Project #20-049
Meadowbrook Subdivision
Located at approx. 2200 South 1600 West

Project Name: Meadowbrook Subdivision
Proponent/Owner: Land Haven INC, Sterling Land Holdings LLC
Project Address: Approximate 2200 South 1600 West
Request: Subdivision Permit
Current Zoning: MR-9
Date of Hearing: Oct. 8th 2020
Type of Action: Quasi-Judicial
Submitted By: Russ Holley, Senior Planner

Figure 1 shows the 9.51-acre addition to the Meadowbrook Subdivision and the additional 1600 West ROW dedication.

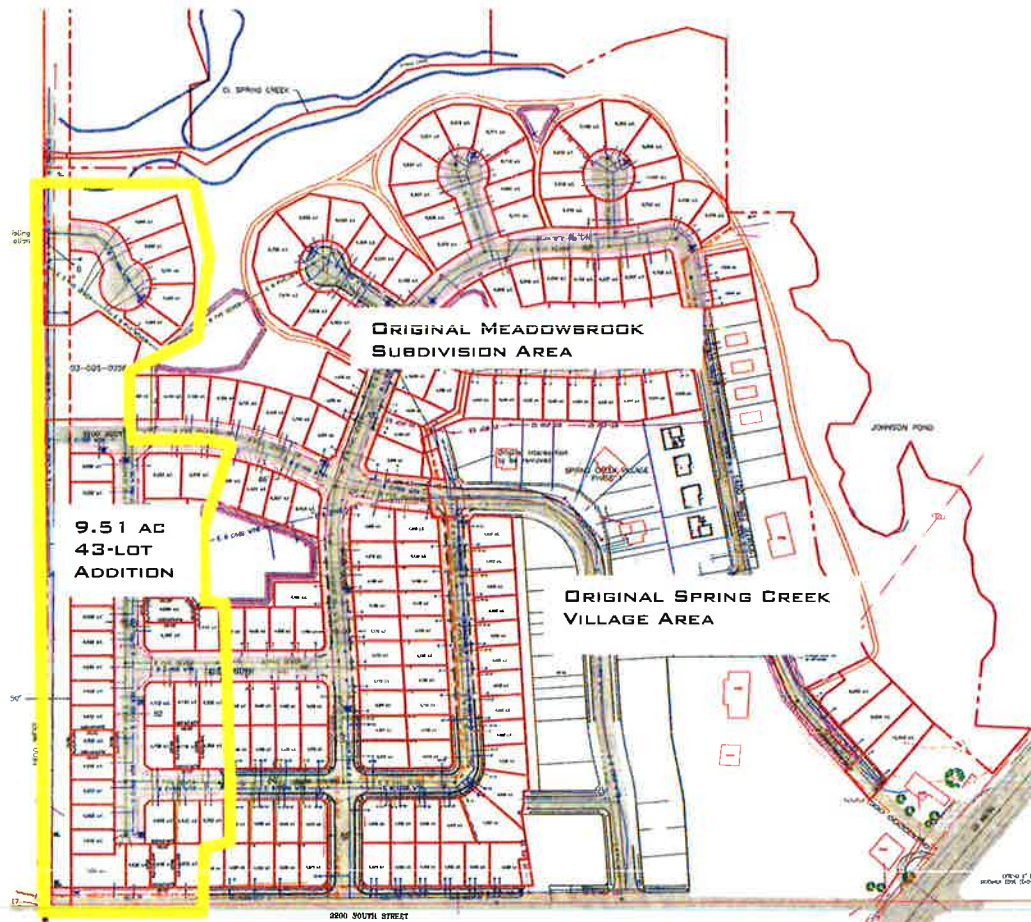
The LDC 17.30.170 requires that subdivisions with greater than 20 lots have at least three (3) adjacent street connections or stubs for future connections. The LDC street connectivity requirement ensures uniform traffic distribution, efficient utility networks, improved walkability and the continuation of traditional core neighborhood layout. This proposal includes the creation of several smaller blocks and numerous internal street connections within the development. Three street connections are shown to the adjacent Meadowbrook phases, onto 2200 south and onto 1600 West. To the north, Spring Creek, makes street connections impractical. The newly adopted Public Works Standards and Specifications, require 60' and 66' street cross-section (Local & Gridded) for traffic movements associated with neighborhoods of this composition. The

proposal also includes additional right-of-way dedication for the regional traffic anticipated along 1600 West. The proposed subdivision meets these minimum street cross sections and connectivity standards as proposed.
